December 5, 2022

Michael Elabarger
Town of Rolesville
502 Southtown Circle
Rolesville, North Carolina 27571

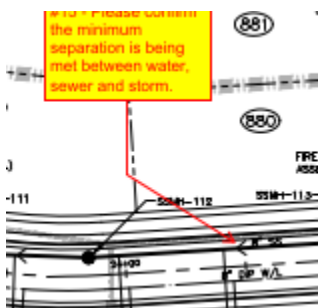
McAdams Response: This was discussed at the TRC meeting. Tim Beasley stated the minimum separation is 3' and 5' is preferred. We checked all the locations shown with this comment and after

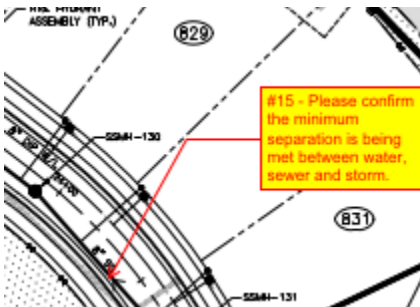
McAdams Response: The water service has been located away from the drainage easement.

McAdams Response: There is no label shown.

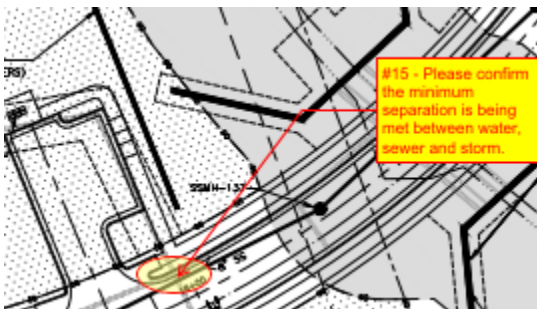
McAdams Response: This was discussed at the TRC meeting. Tim Beasley stated the minimum separation is 3' and 5' is preferred. We checked all the locations shown with this comment and after adjusting a few sanitary sewer alignments, all separations are within the minimum 3' between sewer and storm drainage.

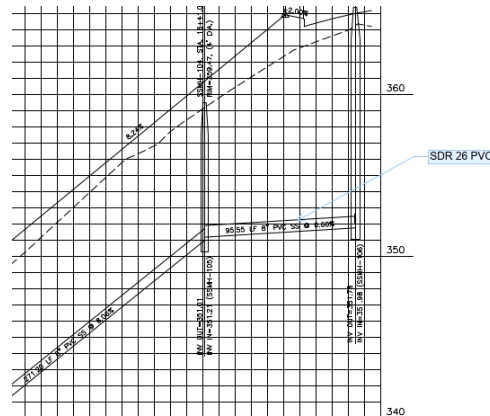
McAdams Response: The note, or approval condition, has been added to the Cover sheet.
